**DTC Modification &
Overall Height Modification**

1221 Broadway

Downtown Code DRC Meeting of 9/5/2019

Figure 1: Broadway Elevation

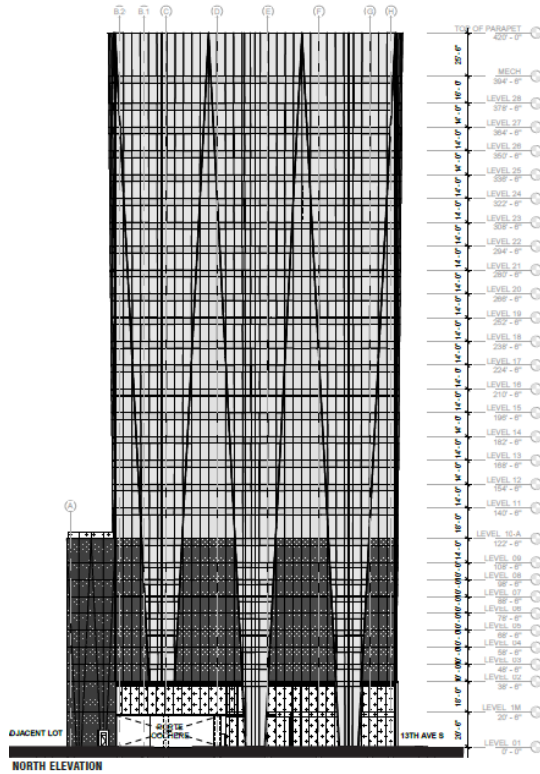
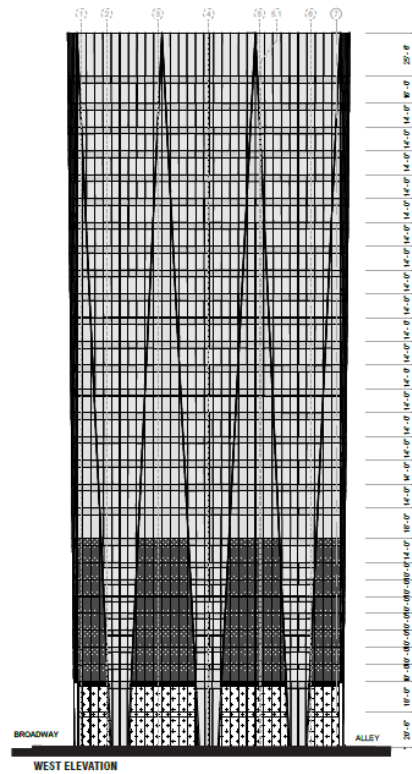
The DTC requires buildings greater than 8 stories to have a 15 foot step-back occur at some point between the 4th and 8th story. The proposed project does not propose a step-back. The intent of a step-back is to allow light and air to reach the street for the benefit of pedestrians and to avoid a canyon effect. Step-backs are most important for narrow streets, as increased proximity of buildings on the other side of the right-of-way has a greater potential to create a canyon effect.

However, step-backs along these rights-of-way are unnecessary in achieving this intent. Broadway is 110' in width, serving as the third widest downtown right-of-way behind James Robertson Parkway and Korean Veteran Boulevard. 13th Avenue North is adjacent to the Interstate, permanently ensuring that no structure will be immediately across 13th Avenue North from this building to contribute to a canyon effect.
